## Response to Referee #1

## Response to Referee #2

**Figure 1.** Comparison for Howard Springs from 2001-2006 (subset from 1980-2017) between the results of Schymanski et al. (2015) (green) and the new results that implemented all changes (VOM-v0.5, red) and the VOM-v0.5 with the water use

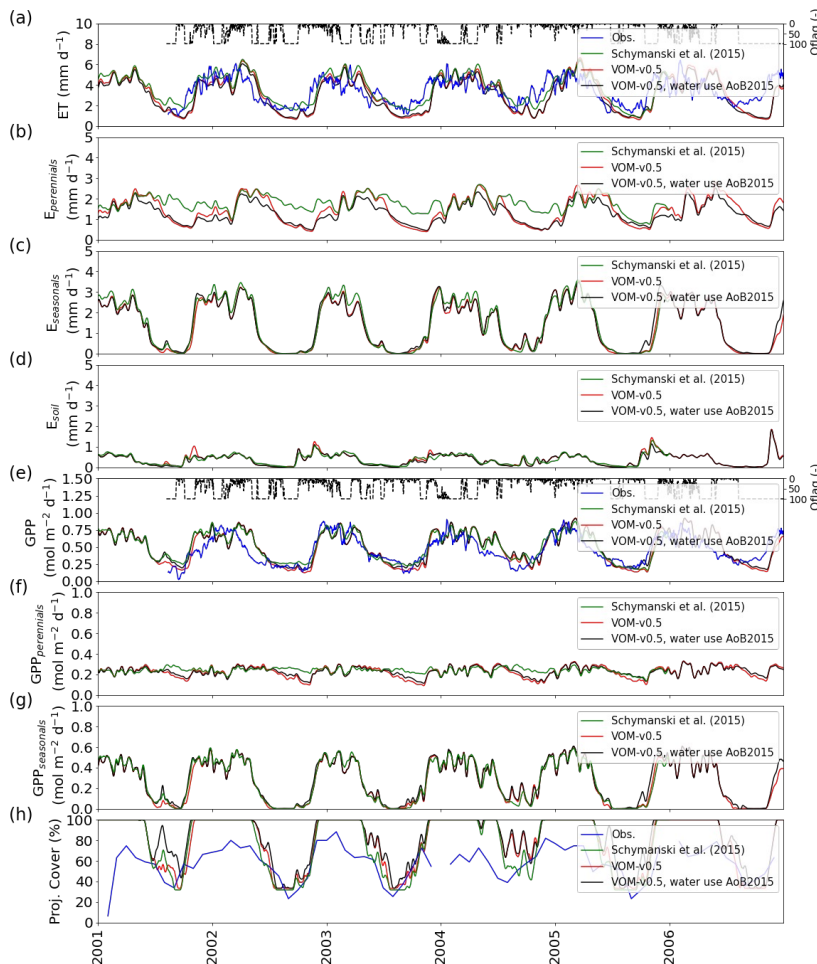
*Lines 311-313: Figs. 6c and 7 do indeed show increased water storage under the new soil textural updates; however, they do not necessarily show greater water availability to plants (i.e., transpirable water) resulting in higher perennial ET. In Figure 6c, the new VOM rooting depths are over a meter shallower than Sc15, meaning comparing the water content in the top 5 m exaggerates the difference in transpirable water since the new VOM roots do not access much water below 3 m. Fig. 7 attempts to offer more support to your claim as the new VOM deep retention curve is more gradual over a larger range of water content compared to the homogenous assumptions in Sc15. However, this does not tell*

us that the additional soil water volume in the root zone is transpirable. The effect of soil textural change on transpirable water in the VOM is determined (to the best of my knowledge) by resistances in soil water uptake, plant water use strategy that determines stomatal sensitivity to soil water potential, and fractional coverage (foliage). From Supplement S1, the reductions in  $K_{sat}$  for the new VOM reduced perennial ET (Fig. S141b), indicating higher resistance in root water uptake. However, changes to both soil texture parameters and  $K_{sat}$  seemingly create a more efficient plant water use strategy (S1.38d and S1.42d) with fractional cover (S1.49e). Therefore, the question is, does the increase in perennial ET from soil texture changes result from greater transpirable water availability due to increased soil water storage? Or altered plant water use strategy? Or both? I think this argument needs to be fleshed out further to truly understand the mechanism for the buffering effect of soil texture on perennial ET.

Thank you for this comment, it involves fair questions that we will have to pay attention to. In a first step, we replaced figure 6c with the water stored in the root zone, instead of the upper 5 meters. In addition, we ran the VOM-0.5 with the “old” water use parameters now, as can be seen in the figure below. Here, it can be noted that the differences between the VOM-v0.5 (red) and the VOM-v0.5 with the water use parameters of Schymanski et al. (2015) (black), are relatively small for the perennial ET, indicating that the largest effect comes from the new soil structure. Nevertheless, also the water use parameters contribute, as the perennial ET slightly increased for the new VOM-v0.5 during the wet season, whereas the values with the old water use parameters remain lower.
